Amendments to the Drawings:

REMARKS/ARGUMENTS

FIG.1A
(PRIOR ART)

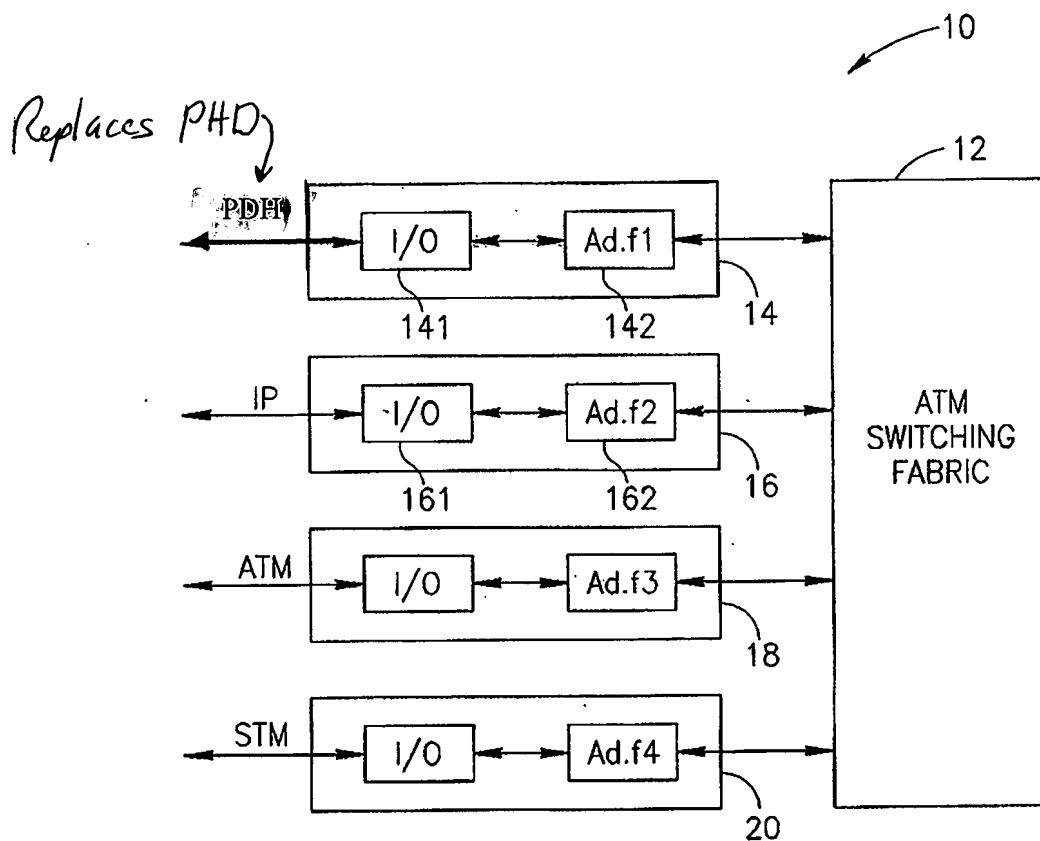
The Examiner objected to FIG. 1A because the term "PHD" was not defined in the specification. This term is a typographical error and should have been "PDH," which term is defined in the specification as amended and is well known in the art to mean, "Plesiochronous Digital Hierarchy." Thus, the change in the drawings does not add any "new matter" to the application.

The attached sheet of drawings includes changes to FIG. 1A. This sheet, which includes FIG. 1A and FIG. 1B replaces the original sheet including the same figures. In FIG. 1A, the typographic error listing the input/output to Box 141 has been corrected by changing "PHD" to --PDH-. Attached also is an annotated sheet showing the changes highlighted in red.
